Architect's Supplemental Instructions Addendum

Project: Samish Xwch'ángteng Development on 34th Street
Anacortes, WA

Addendum/ASI No.: Addendum 03
Date of Issuance: May 23th, 2022

SHEET
A200

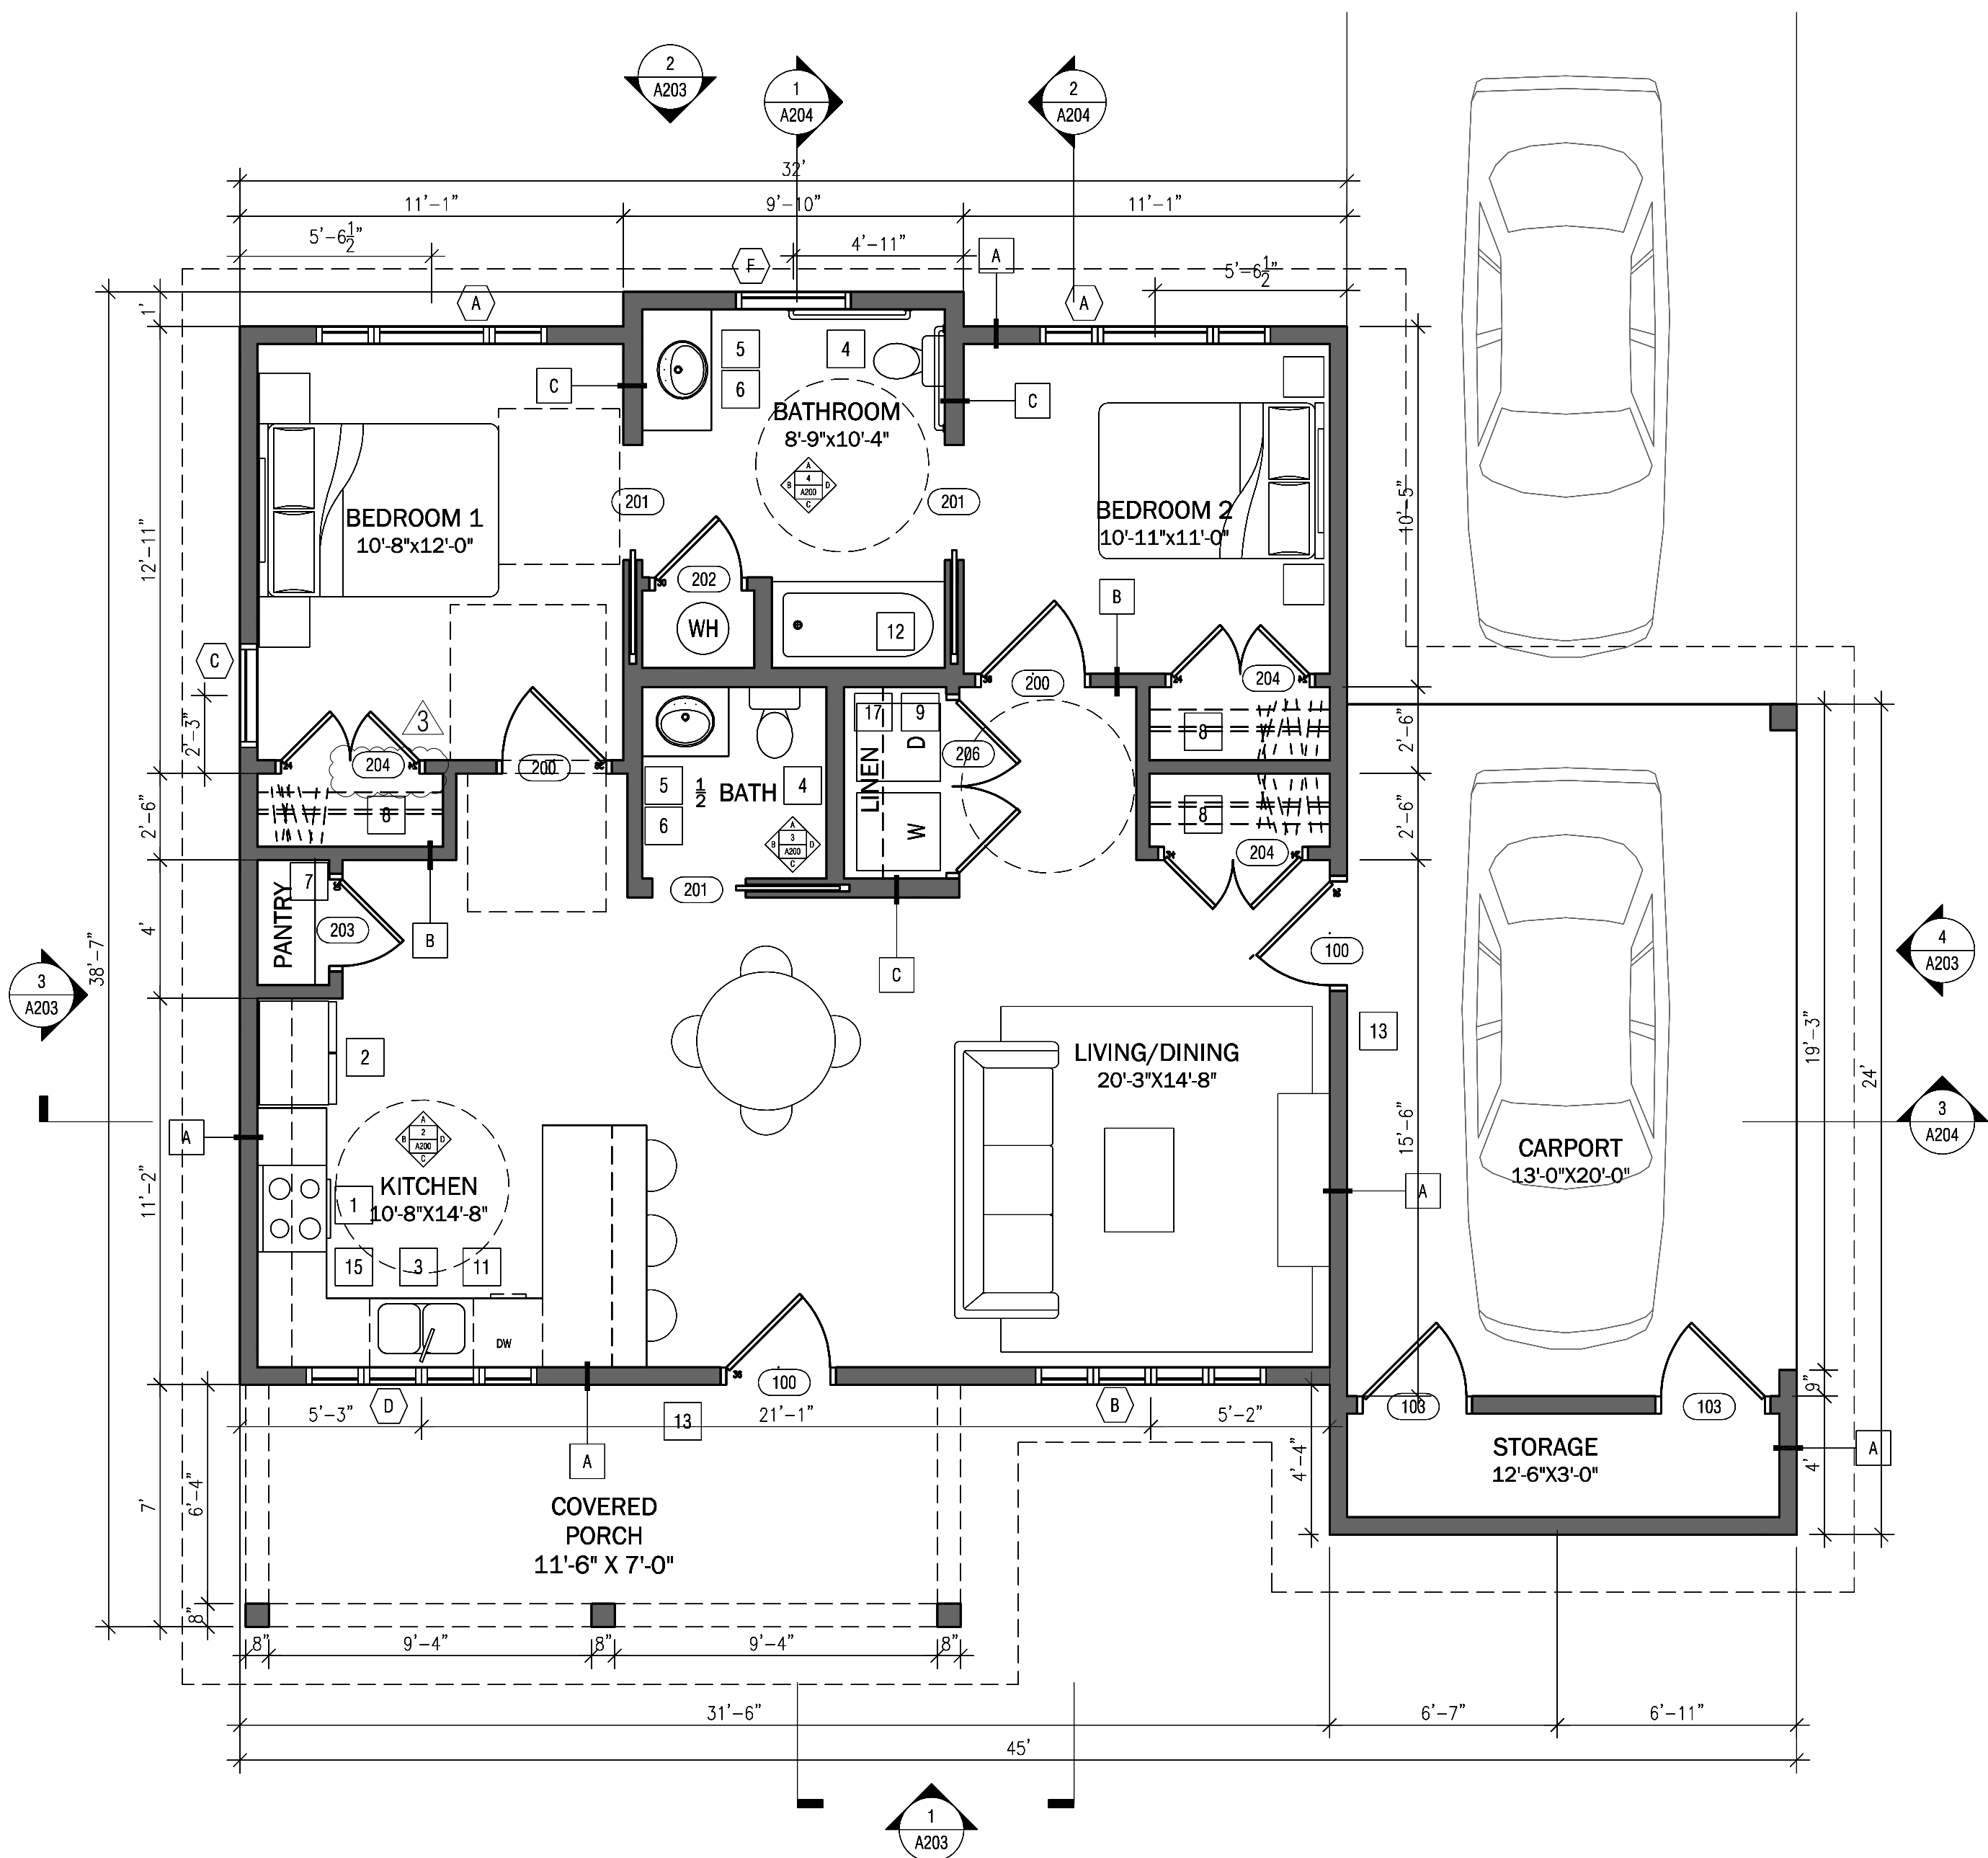
4. Sheet A200 Floor Plan 1 calls for door 203 in Bedroom 1 closet. Bedroom 2 closet calls out door 204. Door schedule shows door 204 as Typ closet door. Please clarify closet door for Bedroom 1. [See attached revised sheet A404](#)

1. Sheet A002 **DIVISION 11A CASEWORK**
2. Sheet A200 Plan **BEDROOM 1 CLOSET DOOR, VIEW 2 & 4 DOOR ELEVATIONS 6 PANEL**
3. Sheet A300 **DOOR ELEVATIONS 6 PANEL**

A401

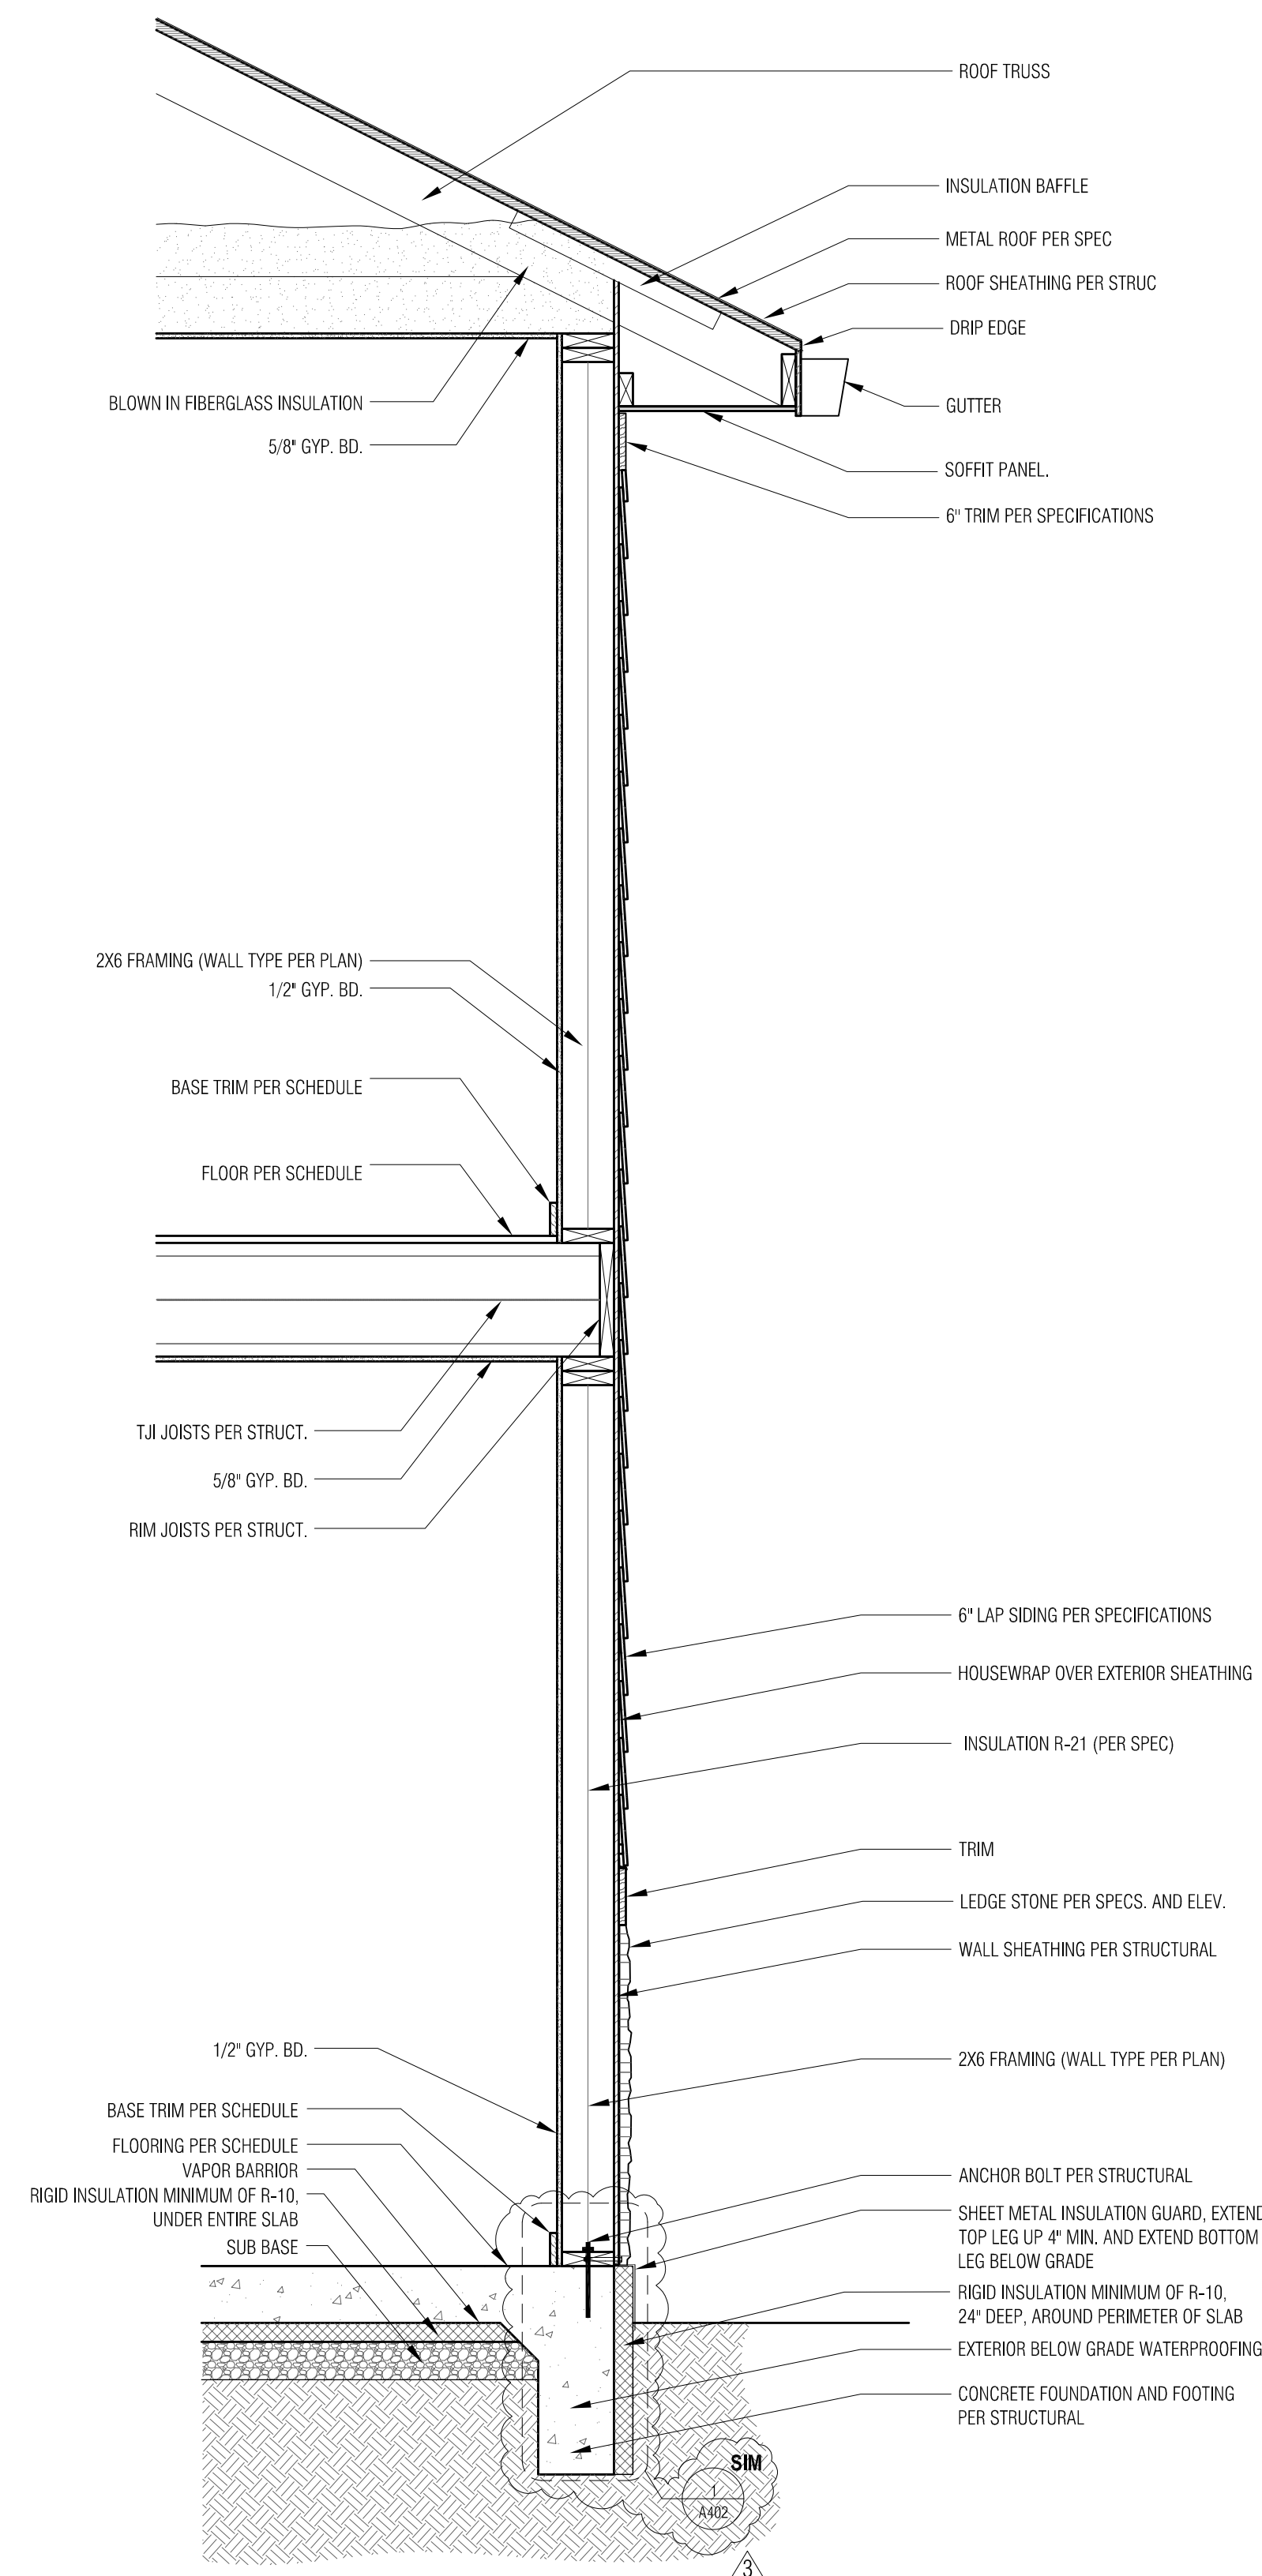
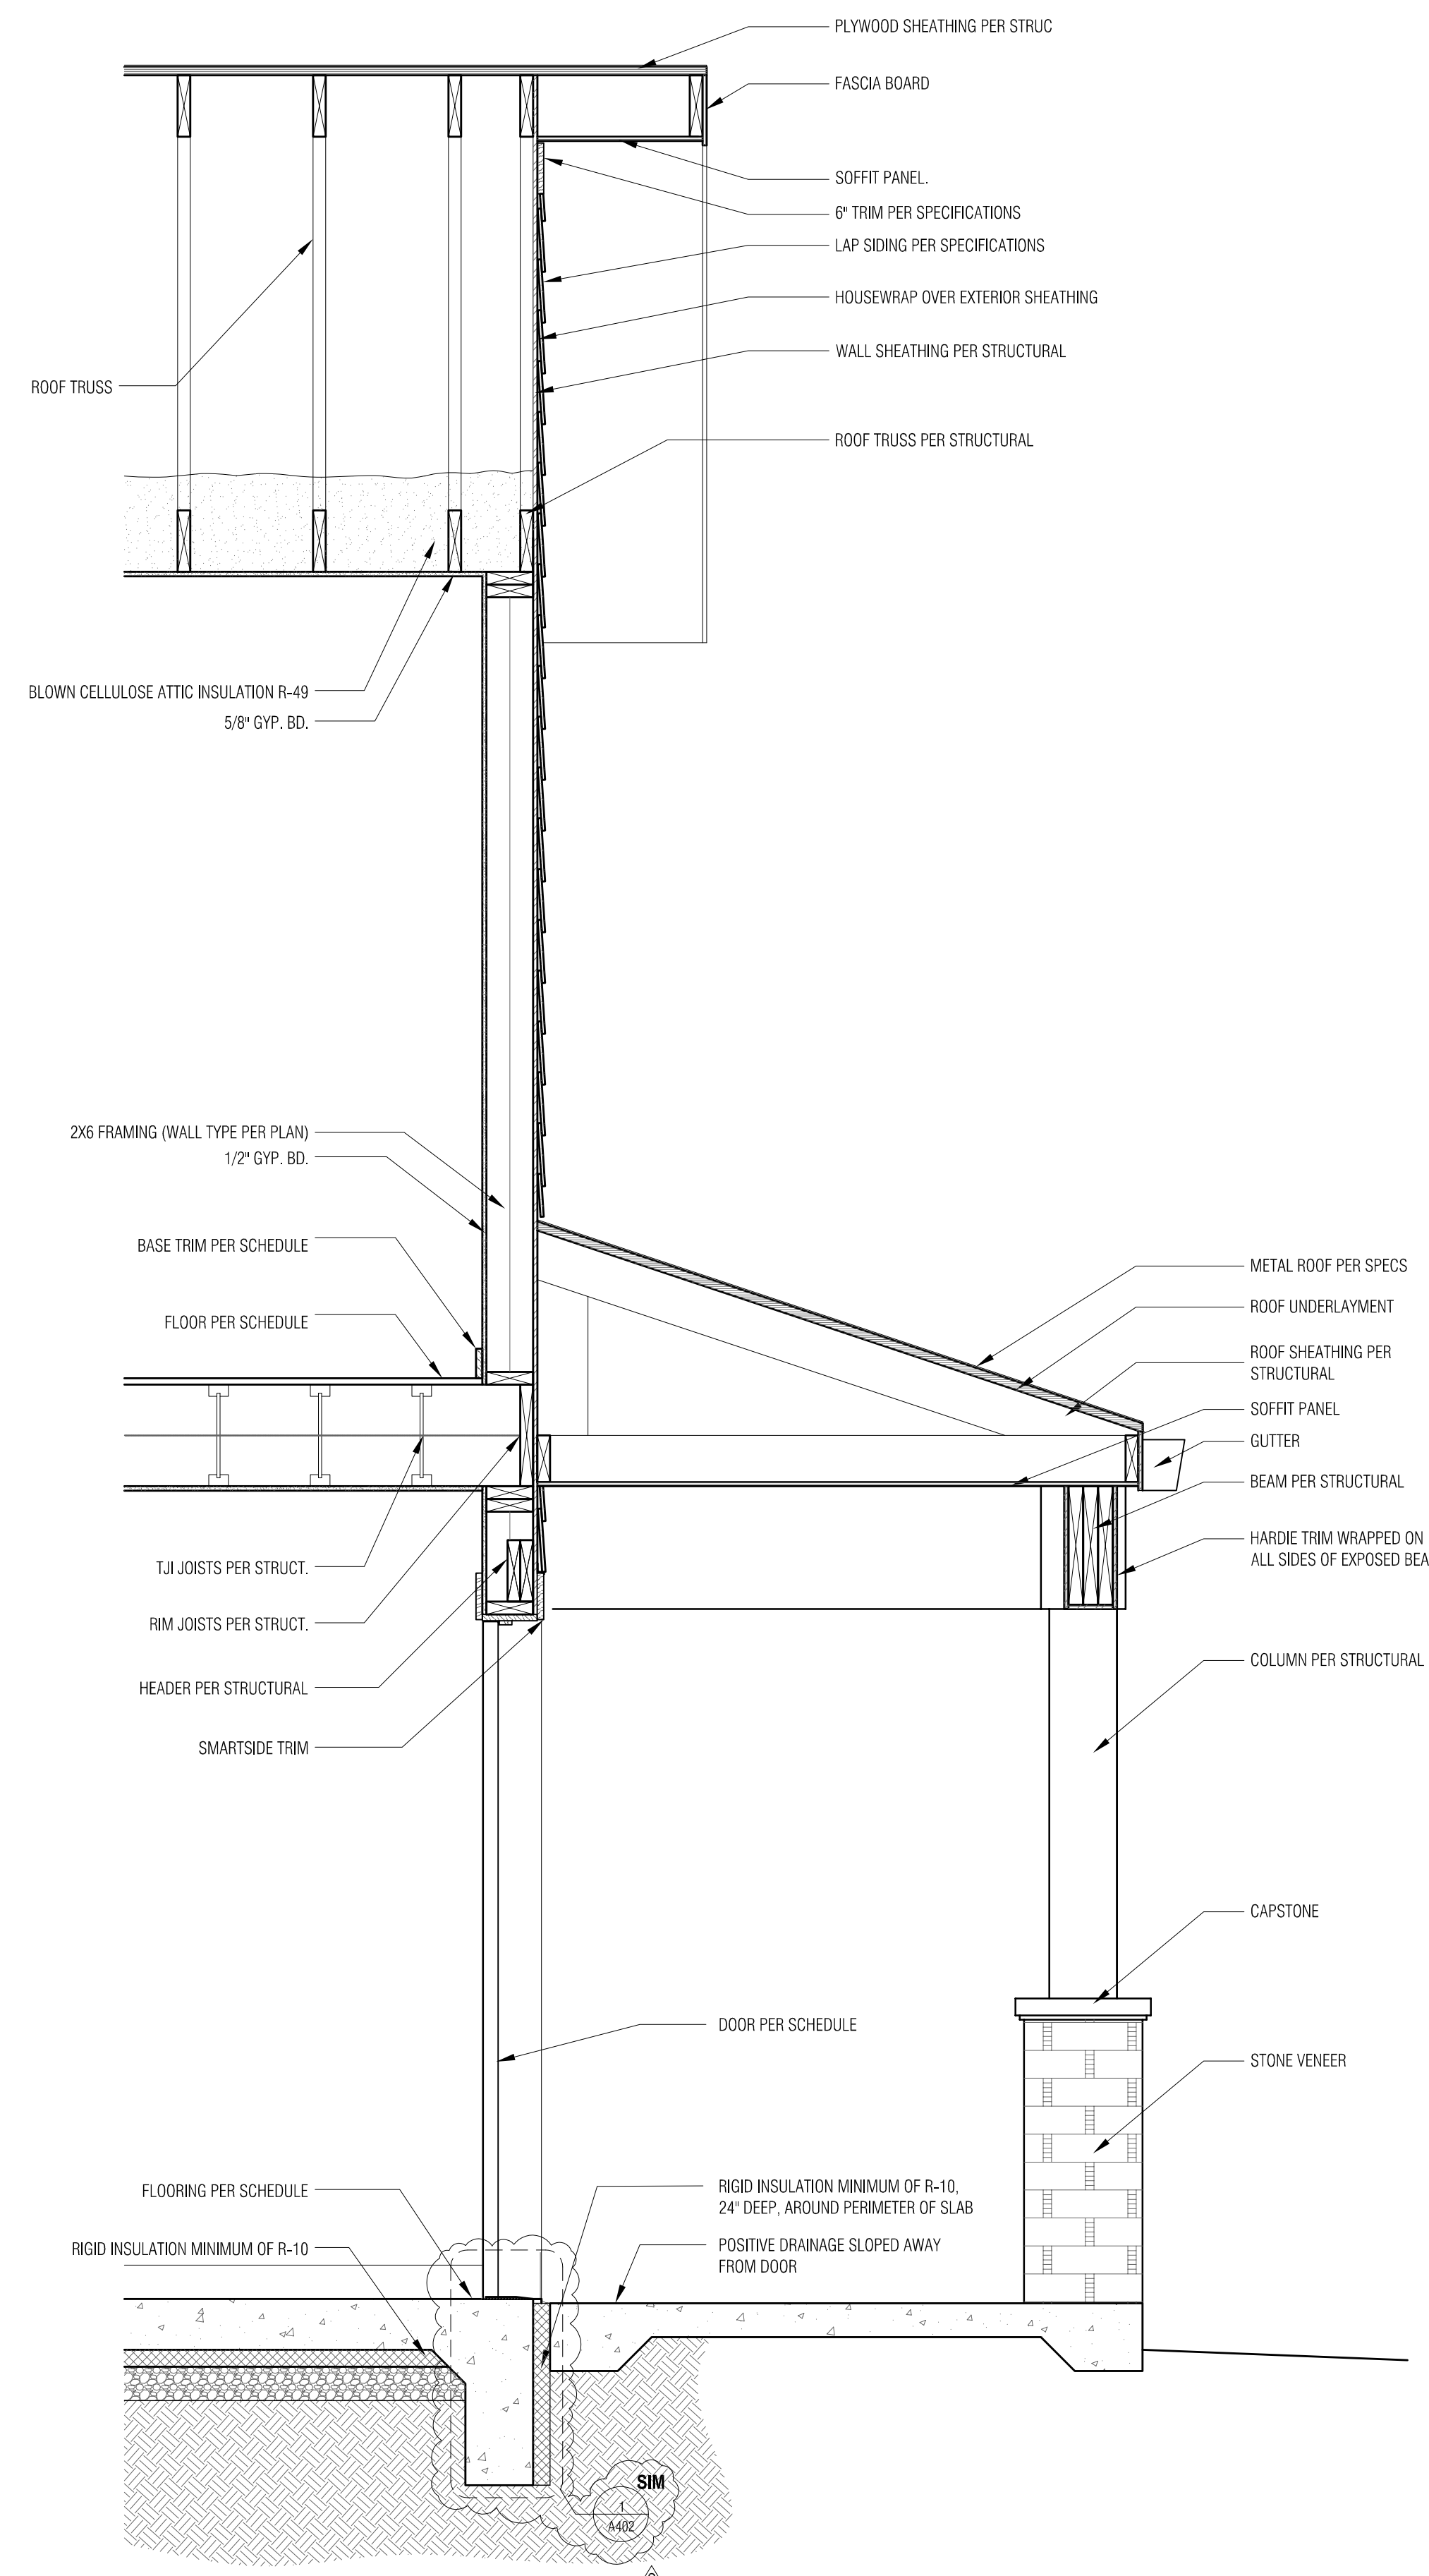
31. City of Anacortes approved set comments A401.: **Provide thermal break at exterior to conditioned slabs.** Typical [see attached revised sheets A401 & A402](#)

4. Sheet A301 **WINDOW TYPE LABEL UPDATED**
5. Sheet A400 Details 1, 2, 3 **CHANGED EXTERIOR INSULATION CHAMFER PROFILE**
6. Sheet A401 Details 1,2 **ADDED THERMAL BREAK INSULATION**, Detail 3 **CHANGED EXTERIOR INSULATION CHAMFER PROFILE**
